Snohomish County
Planning and Development Services

Subject: Point Wells Draft Second Access Report Dated 8/26/15

SUBJECT: Secondary Access – Point Wells Urban Center Development

Point Wells Urban Center Secondary Access Routes

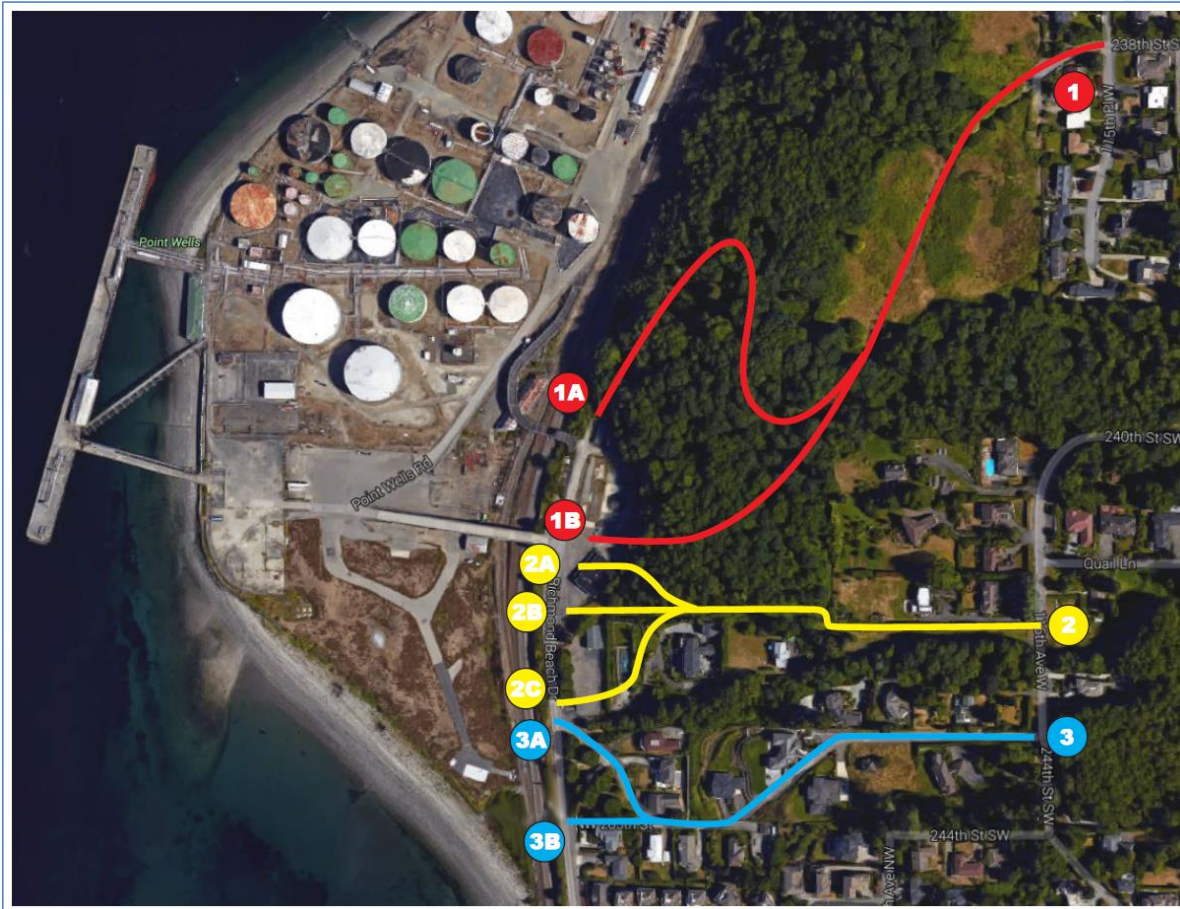
Comment [RMC8]: Snohomish County does not consider ownership by a third party to be a reason to rule this alignment out. We understand from the applicant's perspective that this is a challenging issue, but we often require provision of second access to adjacent properties as a condition for project approval. See discussion of connection requirements for routes 1B and 2A below.

Comment [RMC9]: It should be noted that engineering for this route would likely require EDDS deviations for things like turning radius and grade. However, such a road could be engineered. The real problem is cost based on physical and topographical features of the site.

Comment [RMC10]: Same comments as for route 1A.

Comment [RMC11]: Please revisit the discussion of this route based on the actual width of the strip, which is 20 feet at its most narrow, not 10 feet as implied below.

Comment [RMC13]: The narrowest portion of this strip is 20 feet.

Comment [RMC15]: Snohomish County allows a 15% grade per SCC 30.53A.512(503.2.7) and EDDS Table 3-5 section 3-07A. If Woodway has a different requirement, then both requirements should be discussed.

Comment [RMC17]: Road are allowed through critical areas occasionally and impacts are mitigated per Snohomish County's Critical Areas Requirements. There are also examples of critical areas being impacted within municipal jurisdiction and then mitigated in county jurisdiction.

Comment [RMC19]: Verify per Town of Woodway requirements, and using the 20 foot actual smallest width.

Comment [RMC20]: If this is the only option for a second access, then the building might need to be relocated or eliminated.

Comment [RMC21]: The information provided is insufficient to reach this conclusion.

Comment [RMC22]: Revise per similar issues in Route 2B.

Comment [RMC23]: Provide specific reasons to support the conclusion.
